**Subject:** MHI's Responses to US-APWR DCD RAI No. 496-3735

**Reference:** 1) "Request for Additional Information No. 496-3735 Revision 0, SRP Section: 03.08.05 - Foundations," dated 12/01/2009.

Response to Request for Additional Information No. 496-3735,  
Revision 0

**RAI NO.:** NO. 496-3735 REVISION 0  
**SRP SECTION:** 03.08.05 - Foundations  
**APPLICATION SECTION:** 3.8.5  
**DATE OF RAI ISSUE:** 12/01/2009

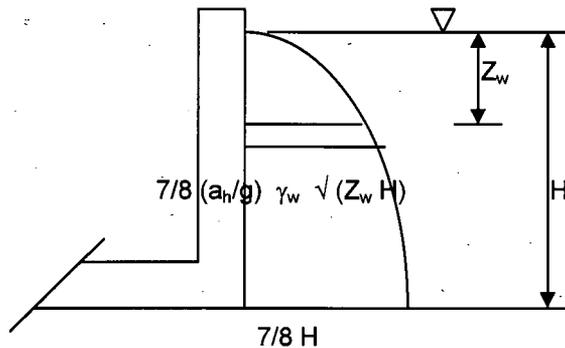
For their response to Part (b) of the question MHI refers to their response to Question 3.7.2-13 of RAI 212-1950, Rev. 1 for the calculation of the horizontal forces. A review of this response to Question 3.7.2-13 was made. In that response, MHI presents a detailed description of how the lateral soil pressures are calculated and presents technical references to support their approach. However, for the US-APWR standard plant design, the water table is 1 ft below the nominal plant grade. So, for underground walls, the soil is submerged under water from 1 ft below the surface. The applicability of Wood's equation to calculate the dynamic soil pressure for the US-APWR standard plant is, therefore, questionable. The applicant is requested to provide numerical data to prove that the effect of water table is negligible and that Wood's equation can, in fact, be applied to the US-APWR standard plant. In the response to Question 3.7.2-13, MHI indicated that a paper by Veletsos and Younan demonstrated that Wood's solution was conservative. However, Veletsos and Younan's paper assumed  $\sigma_z=0$  (the vertical component of the stress tensor) in their study and this assumption is questionable for the case when the vertical component of the seismic motion is considered. In order to support the claim based on this paper, the applicant is requested to show that the conclusion of that paper is also valid if the vertical component of the seismic motion is included, and that the effect of high water table is considered. In addition, Wood's solution does not consider the earth pressure due to the rotation of the wall at its base. The applicant is requested to provide data to show that this pressure is negligible.

The presence of water in the backfill has two effects on the seismic force: 1) it alters the inertial forces in the backfill and 2) it develops hydrodynamic force as noted above. The inertial force must be calculated using effective unit weight  $\gamma_e$  (67.6 pcf) and not  $\gamma_t$  (130 pcf) as was done in the design of the building wall (unyielding wall).

The hydrodynamic forces due to earthquake ground motion are equivalent to the inertia forces of a volume of water attached to the wall and moving back and forth with it, per Westergaard (1931). Westergaard showed that if the harmonic, horizontal motion applied at the base has a frequency lower than the fundamental frequency of the water mass upstream of the wall (i.e.,  $f_0 = v_p / 4H$ , where  $v_p$  is the p-wave velocity of water and  $H$  is the depth of water in the backfill), then the hydrodynamic pressure amplitude increases with the square root of water depth. Note that  $v_p = 4700$  ft/sec (approximately) and for a 20 ft depth of water in backfill the natural frequency = 58.75 Hz, well above the frequencies of interest for earthquake. The amplitude of hydrodynamic pressure is,

$$p_{wH} = 7/8 (a_h/g) \gamma_w \sqrt{(Z_w H)}$$

- $a_h$  = horizontal seismic acceleration in g's
- $\gamma_w$  = mass density of water
- $Z_w$  = height of water mass, (see the figure)
